Technical Information Bulletin

E056

PACCAR MX RC2-RC11 Software Update Campaign

5/17/2012

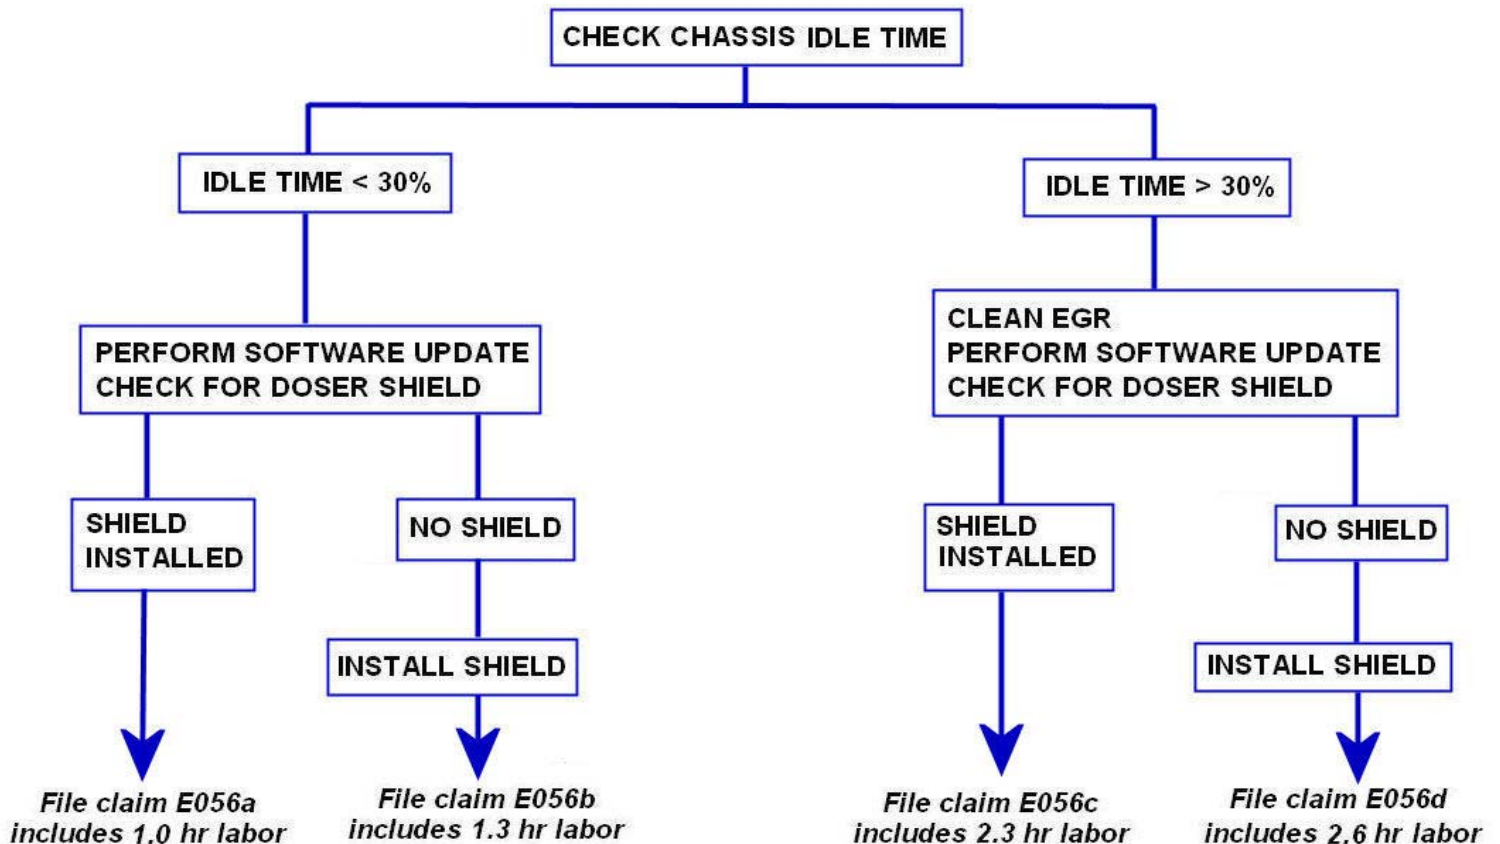
Parts are available from PACCAR Parts. See the Chassis List to identify if a part (doser shield) is required for the chassis being repaired. For repairs requiring EGR cleaning, claims will compensate for up to 2 gallons of flushing solution (sold by PPD in 4 gallon packs).

Quantity	Part Number	Description
1	1894206K1T	Doser Shield – Straight Pipe, shield and clamp
– or –		
1	1894205K1T	Doser Shield – Down, “Cobra” Pipe, shield and clamp
– as req’d –		
2 gal	1109071266	EGR Flushing Solution (part number represents 4 gallons in PPD pricing file)
